UNITED STATES PATENT AND TRADEMARK OFFICE

APPLICATION NO.	FILING DATE	FIRST NAMED INVENTOR	ATTORNEY DOCKET NO.	CONFIRMATION NO.
10/611,694	07/02/2003	Cheng-Fong Chen	SP3019-P-1339-AAF	4432
7590 Cheng-Fong Chen 235 Chung - Ho Box 8-24 Taipei, TAIWAN			EXAMINER GANDHI, JAYPRAKASH N	
			ART UNIT 2125	PAPER NUMBER
DATE MAILED: 11/30/2004

Office Action Summary	Application No. 10/611,694	Applicant(s) CHEN, CHENG-FONG	
	Examiner Jayprakash N Gandhi	Art Unit 2125

DETAILED ACTION

U.S. Patent Jul. 31, 2001 Sheet 1 of 7 US 6,267,297 B1

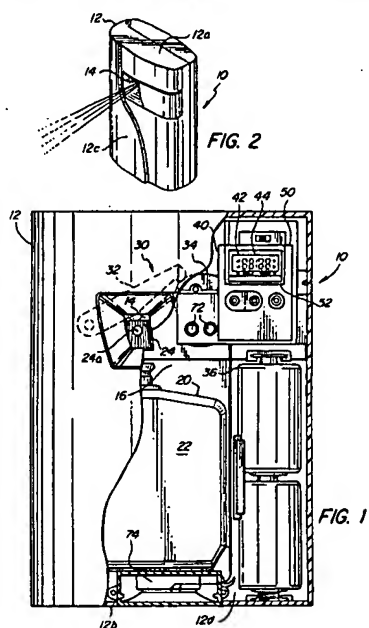
7. Claims 1-6 as best understood are rejected under 35 U.S.C. 102(b) as being anticipated by Contadini et al. (U. S. Patent 6,267,297).

Contadini discloses the claimed invention of a deodorizer control device (programmable dispenser) including a control device 40 with LCD, keyboard, power supply, different operation modes,

even though I/O port, CPU, are not shown but are inherent properties of control device of Contadini to operate.
